# UNITED STATES PATENT AND TRADEMARK OFFICE

APPLICATION NO.	FILING DATE	FIRST NAMED INVENTOR	ATTORNEY DOCKET NO.	CONFIRMATION NO.
10/724,009	11/26/2003	Jurgen Lindolf	INFN/0040	7545
46798	7590	09/13/2005	EXAMINER	
MOSER, PATTERSON & SHERIDAN, LLP GERO G. MCCLELLAN/INFINEON 3040 POST OAK BLVD., SUITE 1500 HOUSTON, TX 77056			HO, TU TU V	
			ART UNIT	PAPER NUMBER
			2818

# Office Action Summary

### **DETAILED ACTION**

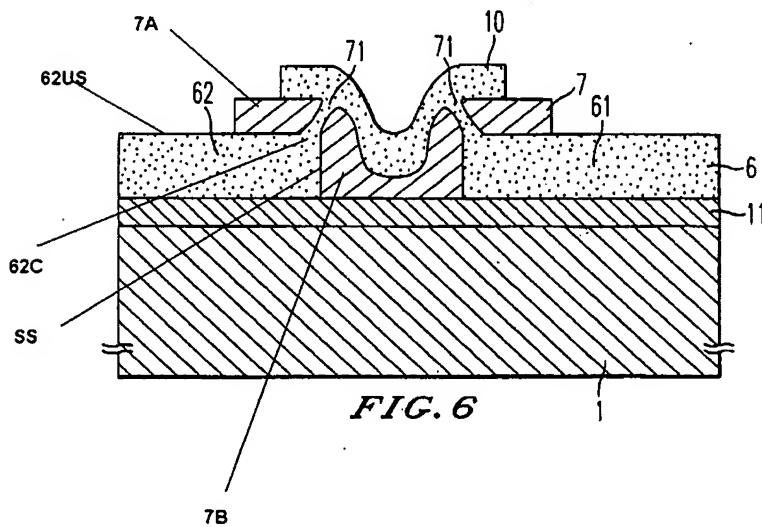
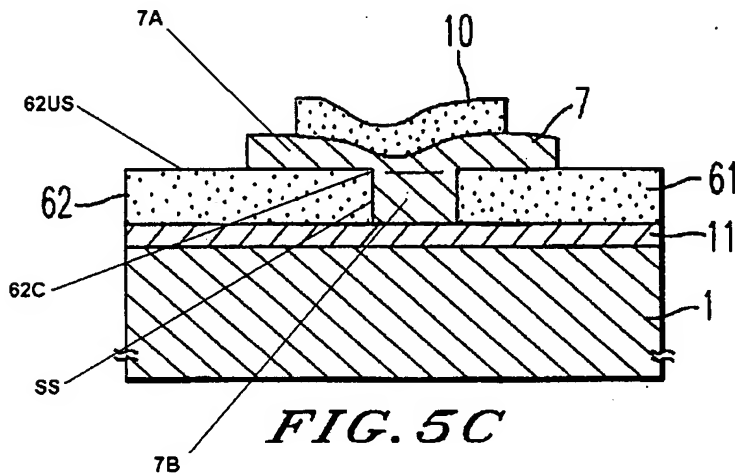
Specifically, Takagi discloses a single region 7 that is functionally equivalent to the nonconductive region 2 and the dielectric layer 4 of the present invention. More specifically and with reference to Figs. 5C and 6, with added reference characters as depicted on the following page for ease of explanation, Takagi discloses an antifuse, comprising:

a first conductive region (62), the first conductive region defining a first upper surface (62US) and a first lateral boundary surface (SS) which meet at an angle (62C) to form an edge;

a nonconductive region (7B) adjoining the first conductive region (62), the nonconductive region defining a second upper surface and a second lateral boundary surface

(SS); wherein the first and second lateral boundary surfaces are in facing relationship and form an interface (generally indicated as SS);

a dielectric layer (7A) disposed over at least a portion of the first upper surface (62US) of the first conductive region and at least a portion of the edge (62C), whereby an area of relatively increased field strength is produced during application of a programming voltage to form a

breakdown channel (71) in the dielectric layer; and a second conductive region (10) on the dielectric layer.

As noted, Takagi discloses a single region 7 that is functionally equivalent to the nonconductive region 2 and the dielectric layer 4 of the present invention. Although the claimed invention is not identically disclosed or described by Takagi, the subject matter as a whole would have been obvious at the time the invention was made to a person having ordinary skill in the art to which said subject matter pertains. The subject matter as a whole, providing a dielectric region (7) including a dielectric portion (7A) and a nonconductive region (7B), as disclosed by Takagi, or providing a dielectric region including a dielectric layer (4) and a nonconductive region (2), as claimed, so that an area of relatively increased field strength is produced during application of a programming voltage to form a breakdown channel in the dielectric portion (7A) or dielectric layer (4) would have been obvious at the time the invention was made to a person having ordinary skill in the art to which said subject matter pertains, simply because neither variation, namely providing a dielectric region (7) including a dielectric portion (7A) and a nonconductive region (7B), as disclosed by Takagi, or providing a dielectric region including a dielectric layer (4) and a nonconductive region (2), as claimed, produces a product that is a newer or a useful improvement thereof over the other.

Referring to **claims 15, 30, and 37**, Takagi further discloses that the conductive region (62) defines a corner (62C) and wherein forming the dielectric layer (7A) comprises forming the dielectric layer over the corner. Referring to the limitation “area of relatively increased field strength” of claim 37, the area of relatively increased field strength results in the breakdown of the dielectric layer 7A at the corner and the eventual forming of the path 71).

Referring to **claim 16**, Takagi further discloses that the first conductive region (62) and the nonconductive region (7B) form a substantially planar upper surface which interfaces with a lower surface of the dielectric layer (7A, best seen in Fig. 5C).

Referring to **claims 18-20, 34, and 45**, Takagi further discloses that the nonconductive region (7B) comprises SiN and the dielectric layer (7A) comprises SiN (column 6, lines 61-63).
